Summit Homes
Winfield Farmhouse

RE: CITY COMMENTS FOR 1617 SW BUCKTHORNE ST, LEE'S SUMMIT, MO 64082

Everstead Engineering & Design, LLC has updated the above-mentioned property construction documents per city comments as follows:

Residential Plan Review

A3.0

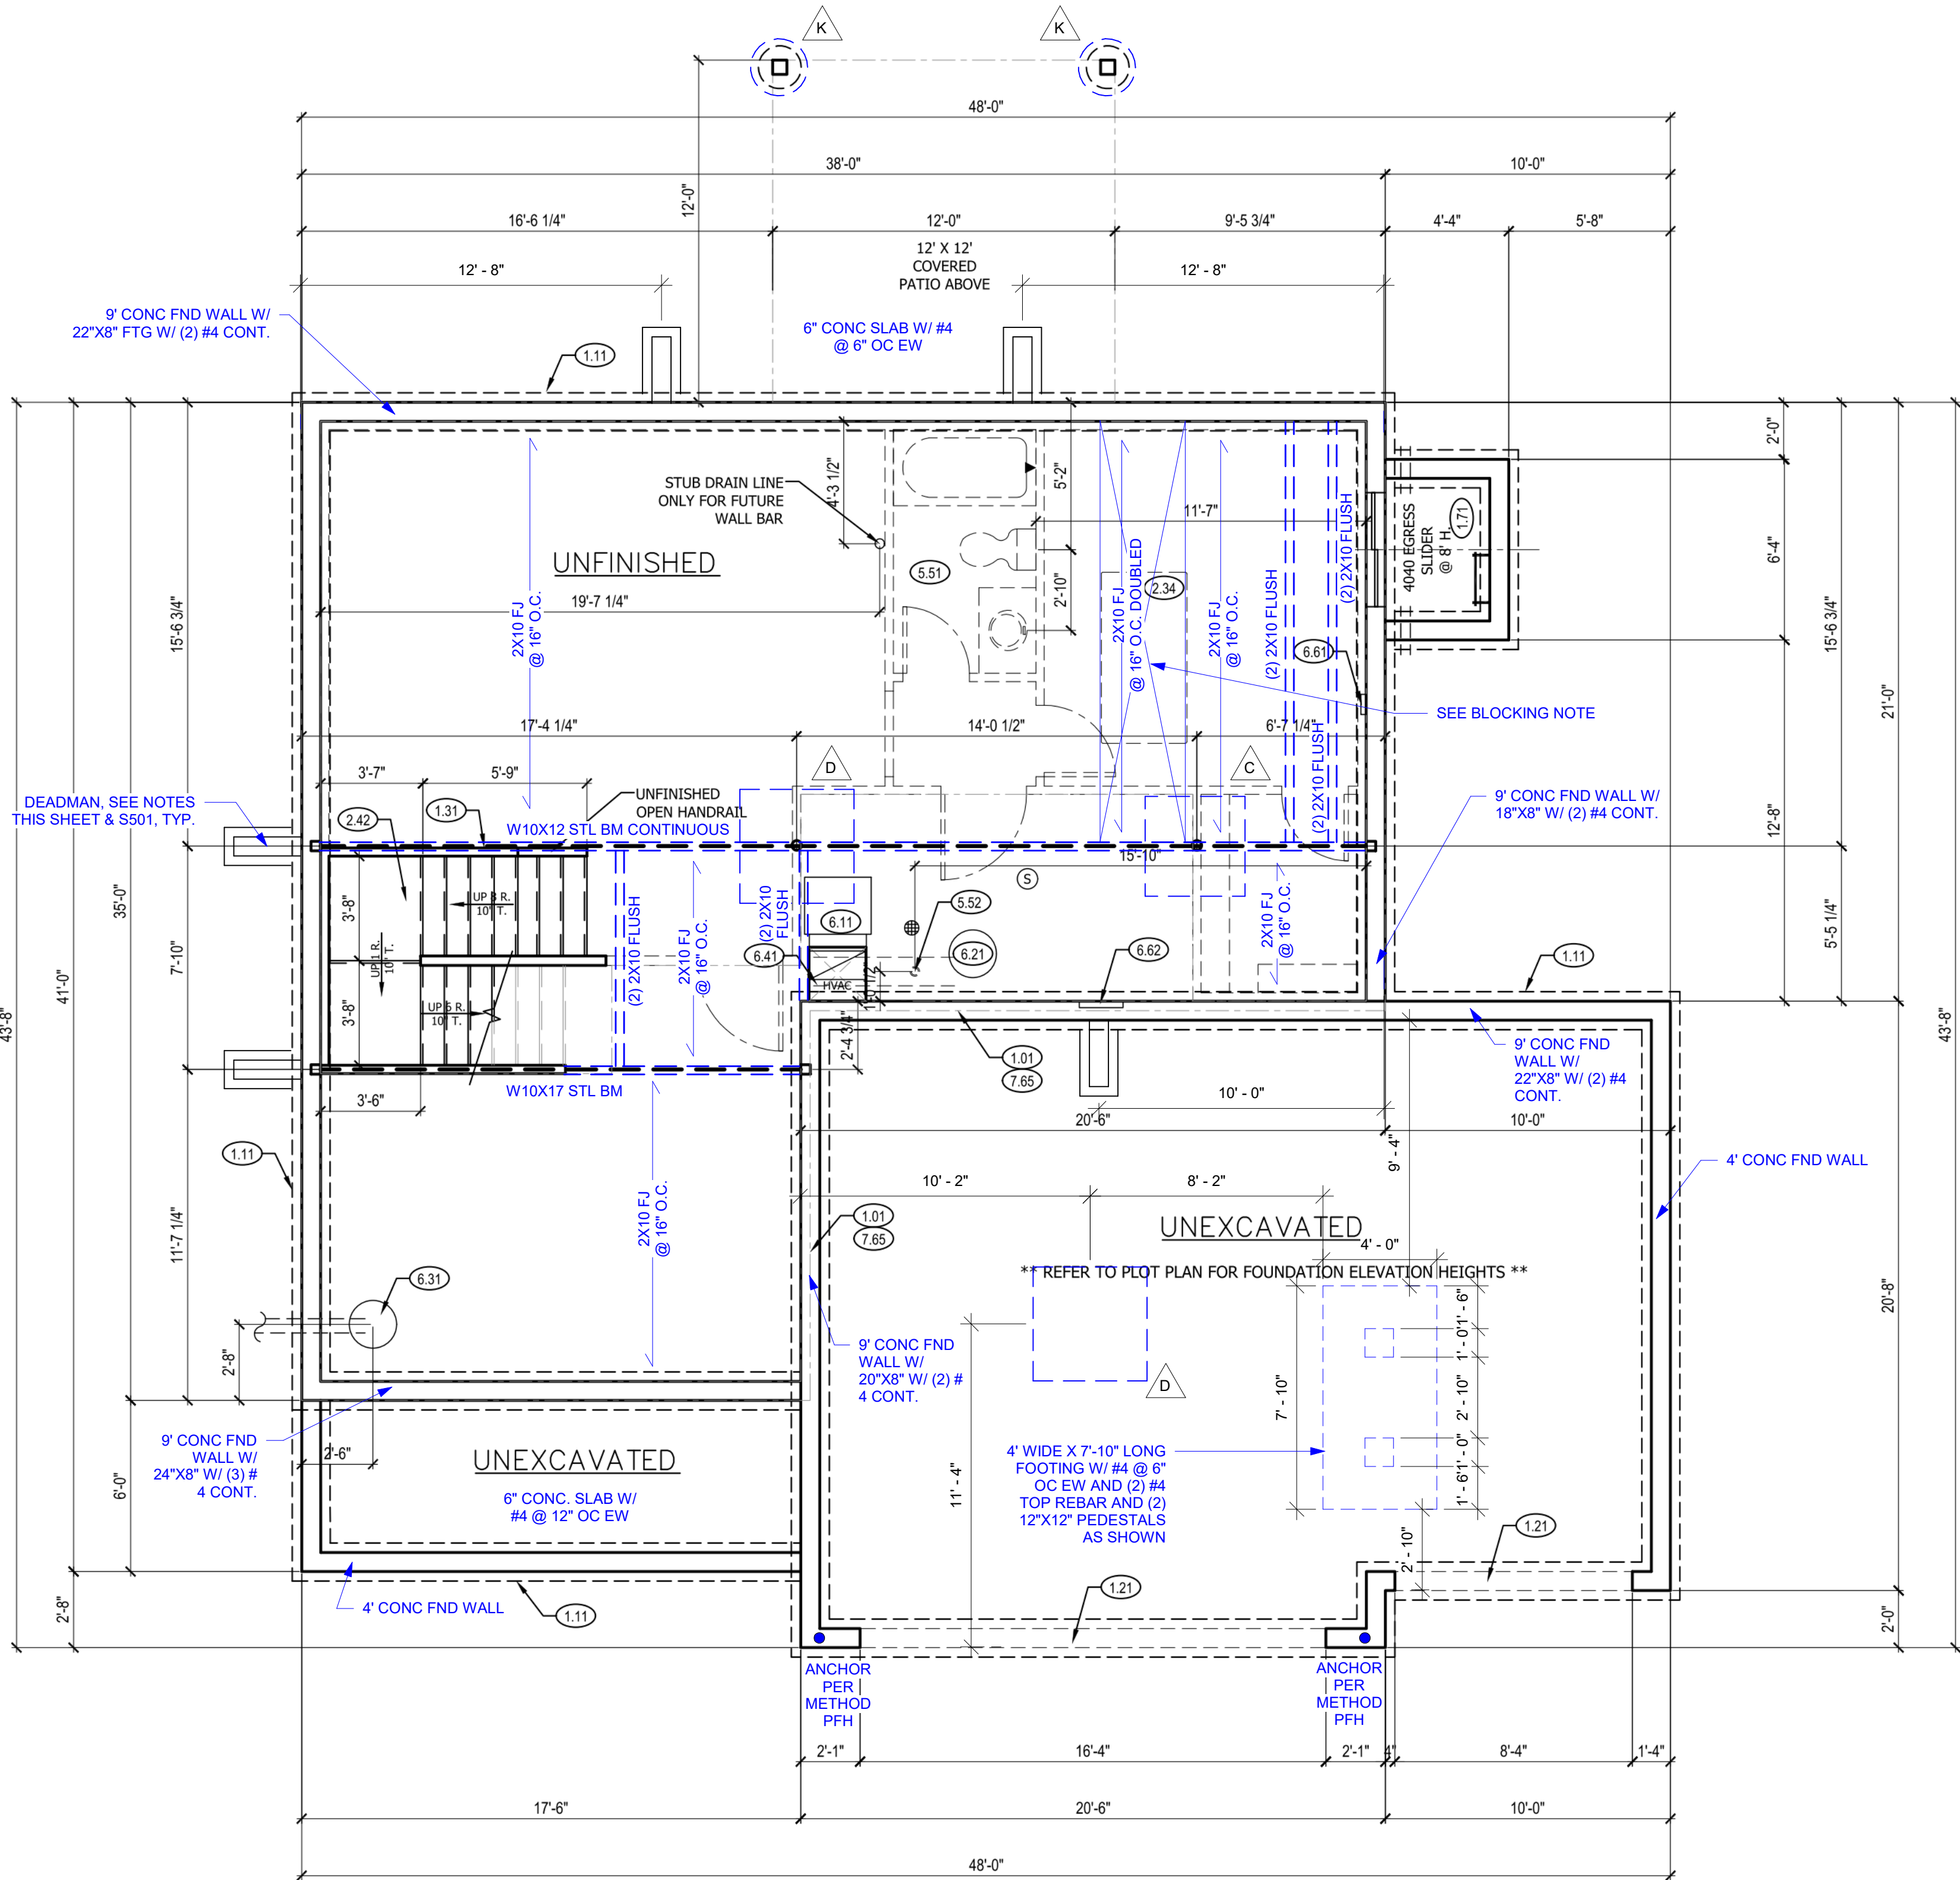
City Comment #3. "Provide details for any walls over 10 feet in height. Include stud grade, size, spacing and actual, uninterrupted height. (IRC Section 602.3.1 and Table 602.3(5) & 602.3.1)."

Engineer's Response – The only wall that exceeds 10' is the full height wall adjacent to the stairs which is 18'-1". It is Douglas Fir #2 or better with 2x6 studs spaced 16" on center, see sheets A3.0 and A4.0.

A4.0

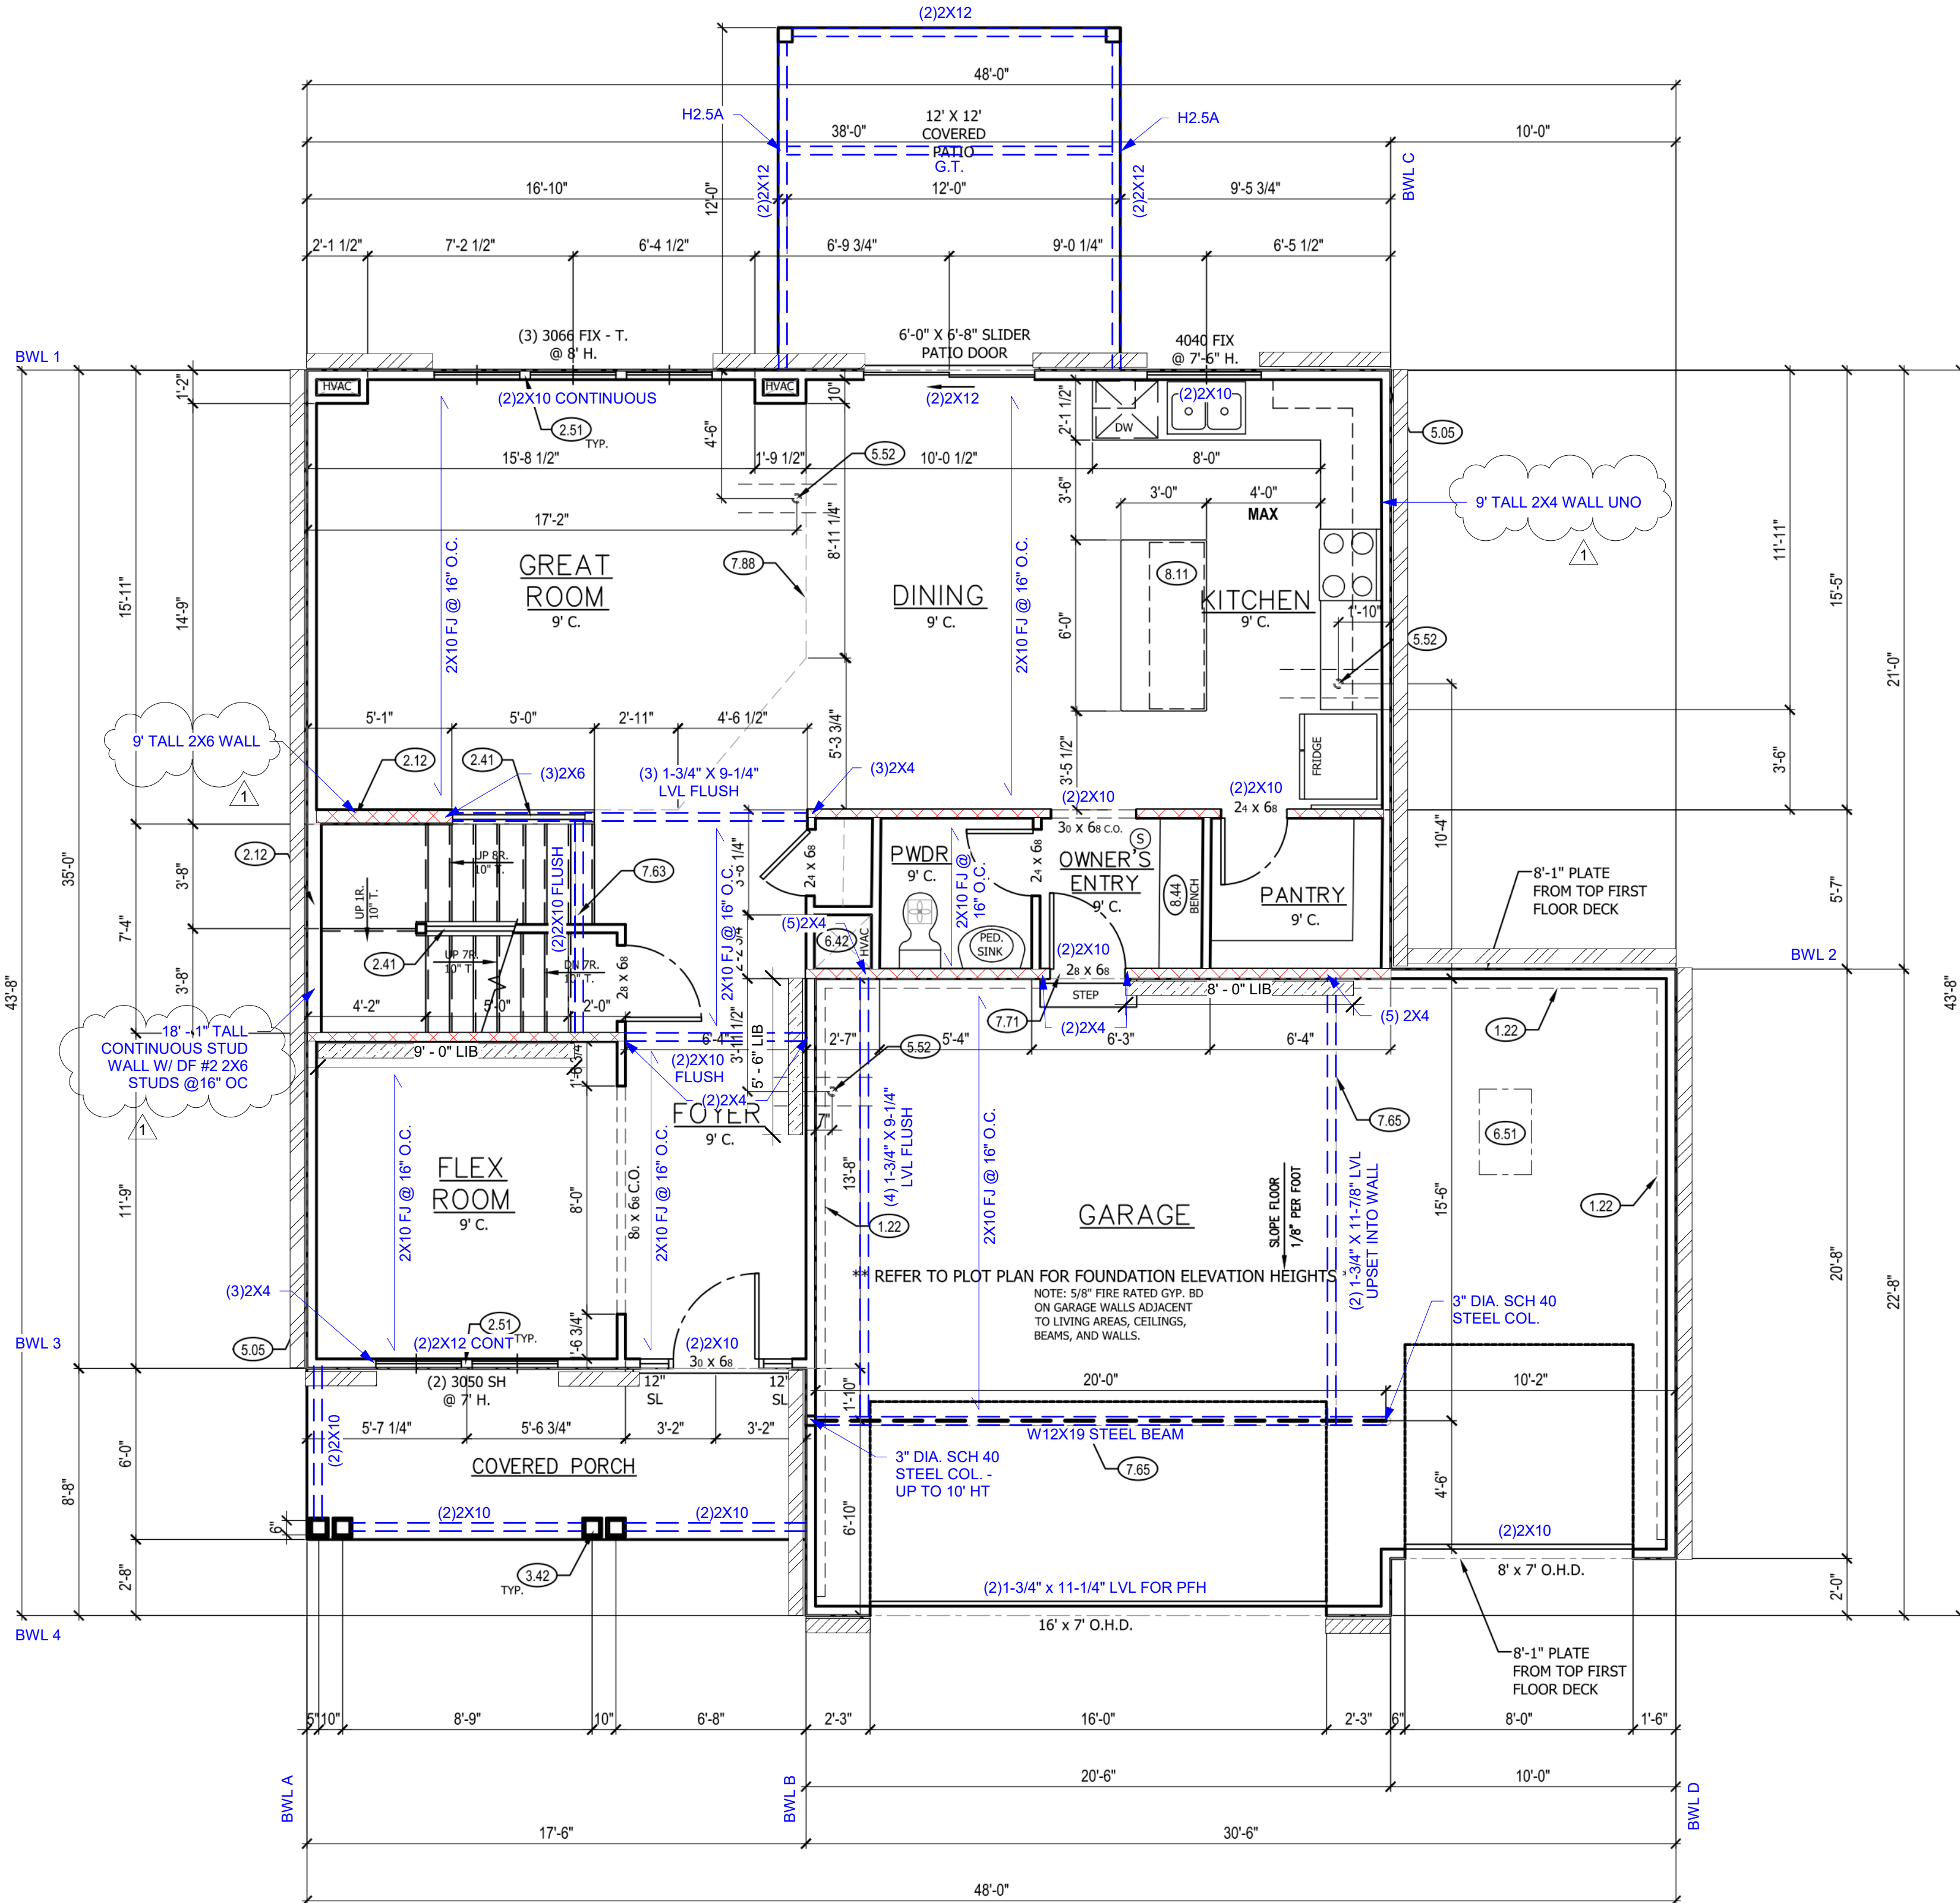
City Comment #2. "Size, height, spacing of studs. (IRC Section R602.3.1)."

Engineer's Response – All studs in bearing walls are spaced at 16" on center unless noted otherwise, see general plan notes in bottom right-hand corner of sheets A4.0 and A5.0. Wall heights and member depths are specified on plans, see sheets A4.0 and A5.0.
